FOX BROOK GOLF COURSE AND COMMUNITY

GRANBY, CONNECTICUT

Eastern Connecticut Environmental Review Team Report

Environmental Review Team
Report #495

Areas of Archaeological Concern

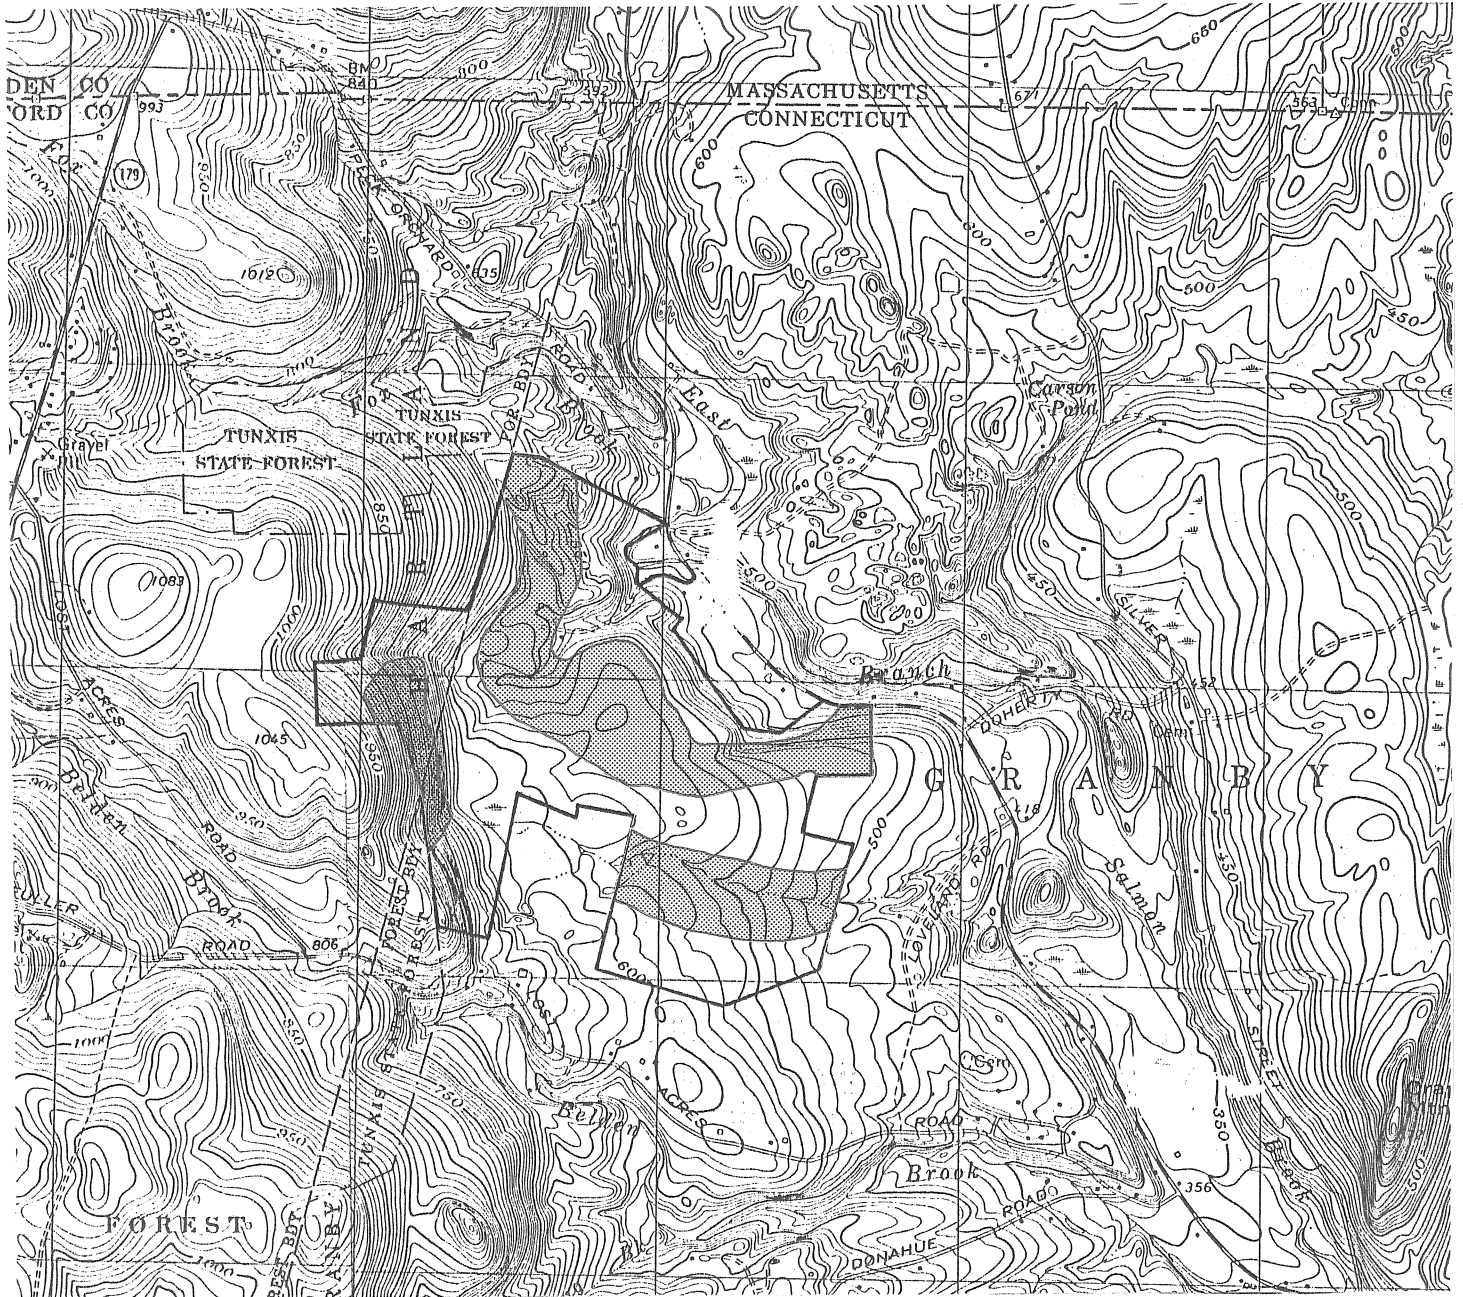
Based upon environmental factors, including soil type, slope, drainage patterns and bedrock outcropping, the area's potential for yet undiscovered archaeological sites probably ranges from medium to high sensitivity. The following map highlights areas of archaeological concern.

The Office of State Archaeology and the Connecticut Historical Commission highly recommend a reconnaissance survey of the sensitive areas to identify and evaluate all archaeological properties which may exist. All survey work should be undertaken in accordance with the Connecticut Historical Commission's ENVIRONMENTAL REVIEW PRIMER FOR CONNECTICUT'S ARCHAEOLOGICAL RESOURCES.
